Marketing Device Connection Technology
 Heiko Steinkamp
 31. October 2014

**Change of the solder pin and spring actuator of the PTS 1.5 – KAA140004 product series
 Please forward this information to your electrotechnical departments!**

Old production status	New production status
 <p data-bbox="400 1758 580 1792">General view</p>	 <p data-bbox="1054 1771 1230 1800">General view</p>

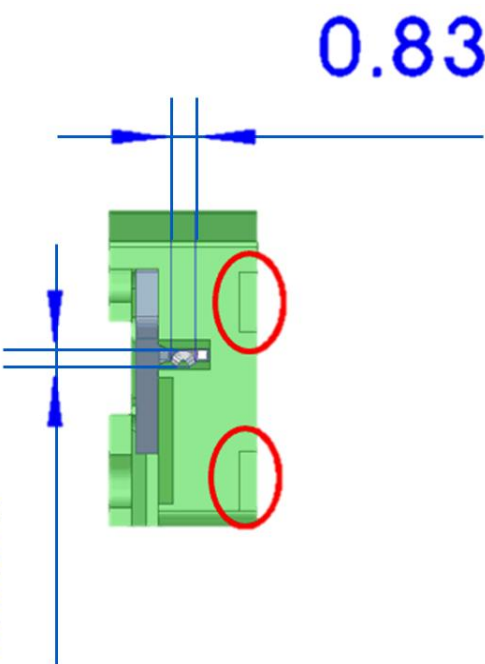
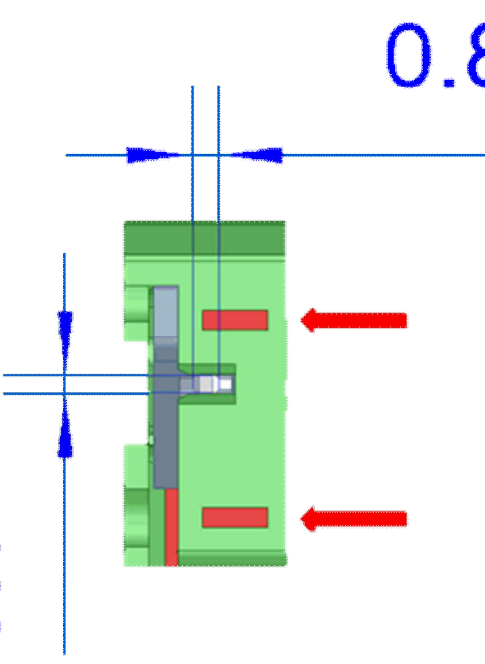
In the course of our continuous improvement process, the shape of the PTS 1.5 solder pin will be optimized. The material thickness and the shape of the solder pin are changed to improve the stability on the PCB. The hole diameter of 1.2 mm will not be changed so that changes in the layout of the PCB are not required.

In the course of this improvement, the shape of the spring actuator will be changed on the one hand in order to strengthen the actuator and to be able to ensure the optimal guide in the housing. On the other hand, the position of the spacer ribs will be changed for an improved stability of the PCB terminal block on the PCB.

The technical features, plug-in behavior and dimensions will not be influenced by this change.

The existing stock can still be used. The new version will be delivered as of June 1, 2015.
